# PERMIT

## SEWAGE DISPOSAL SYSTEM

#### HOWARD COUNTY HEALTH DEPARTMENT

SUBDIVISION Kings Grant LOT 2 ROAD 3207 Parliament Place

INDICATE NORTH - NAME ADJOINING ROADWAY AS BASE LINE

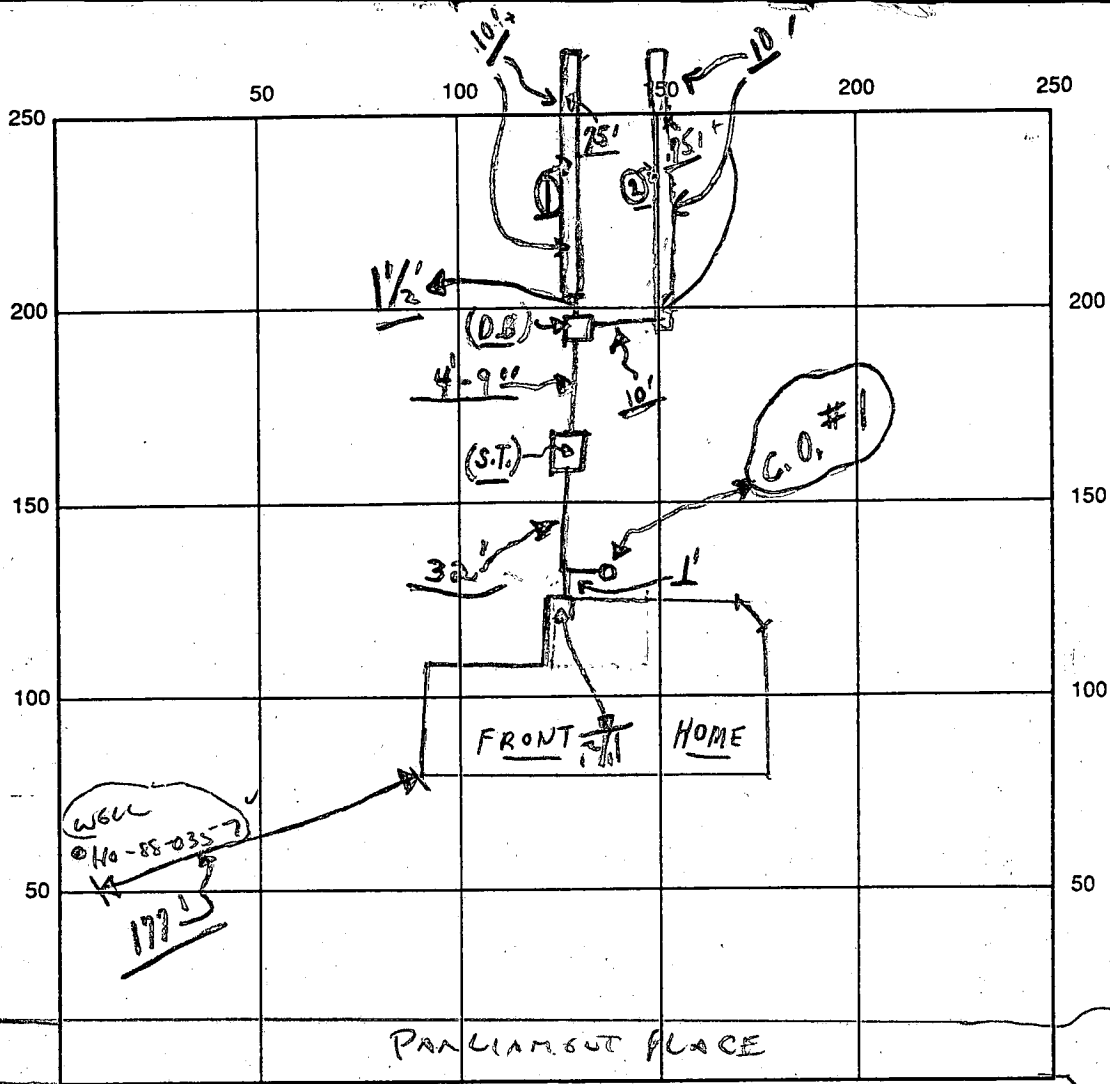
REMARKS: 10/29/92 PAS-INSTALLATION INSP. OK TO ADJUST TANK LOCATION TO PROVIDE CLEARANCE FOR 20-25' DECK. CW.

A. 10/30/92 OK for stones in #0 trench. Partial OK to cover from house to access table. B. Late P.M. - Partial OK to cover #0 trench except for ends + middle, c.B. Very late - Final OK to cover as per c.B. (Material on site)

Owner Name: *VARTAN YOUSEFIAN*  
 Property Address: *lot #2 Parliament Ave*  
 Owner Signature: *Vartan Yousefian*  
 Date:

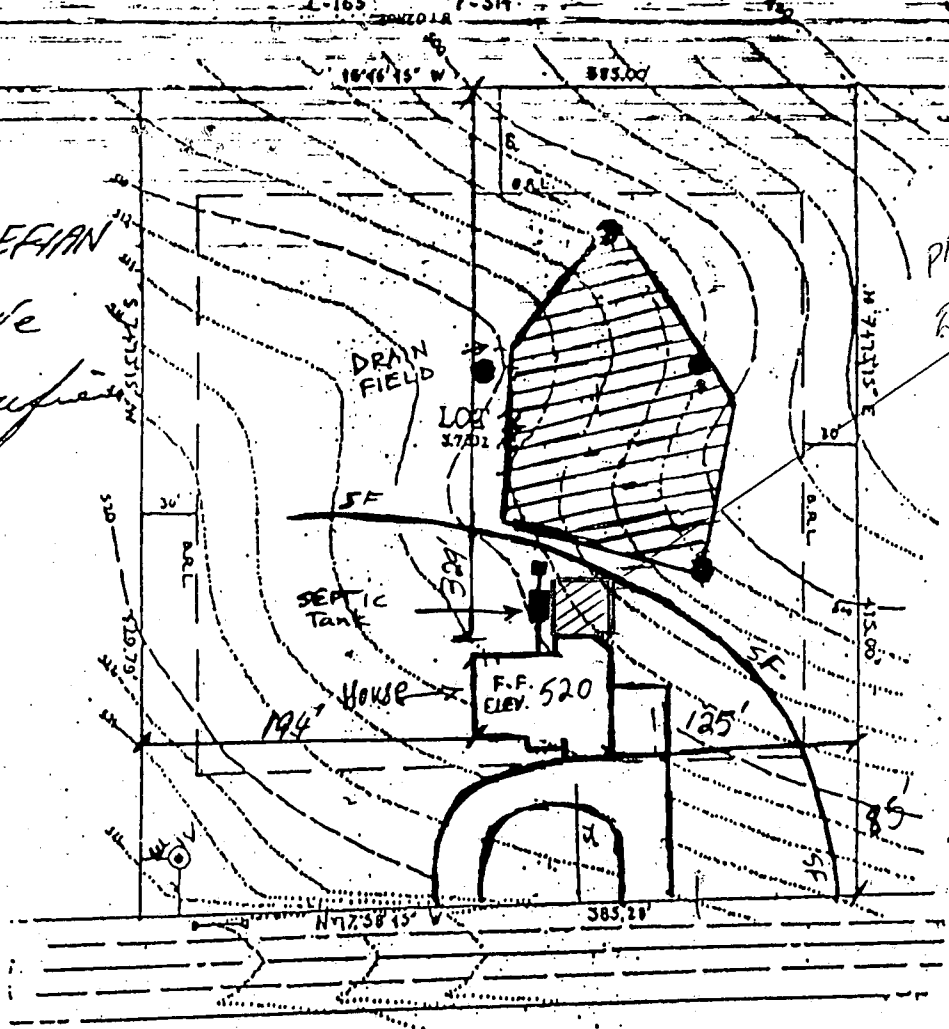
*4/29/93*  
*OK TO SIGN*  
*BP 48198*  
*B. Hodge*

KINGS GRANT  
LOT 2  
4 BEDROOMS

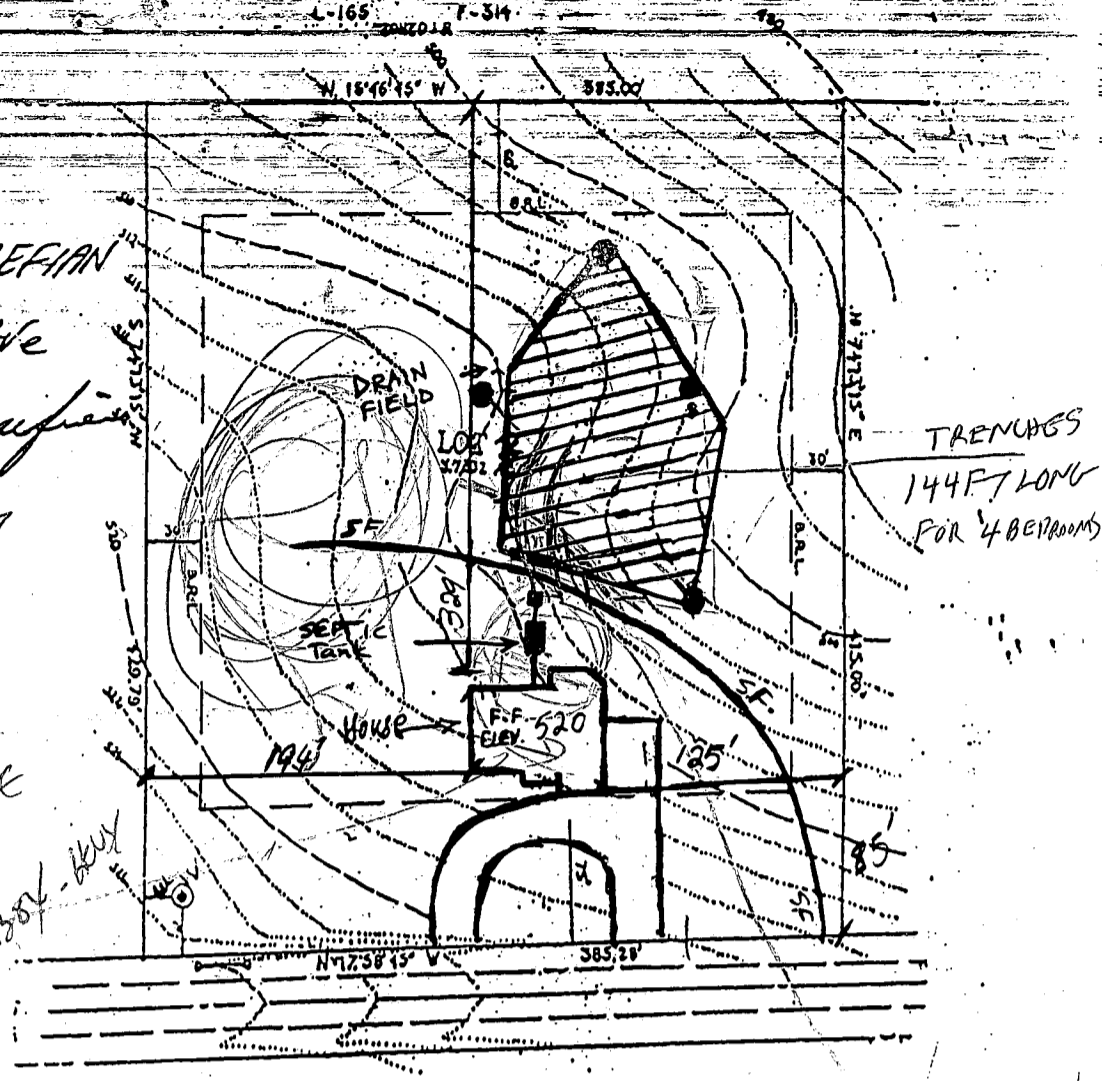
4/1/92  
 PLANS NOT QUITE RIGHT  
 MUST CALL OWNER (BID)

4/3/92  
 REVISED PLANS OK  
 AFTER RED LINE CORRECTIONS  
 & ADDITIONS & SPECIAL LETTER ABOUT  
 HOUSE EXCAVATION INSPECTION  
 BUDGES  
 BP 41833
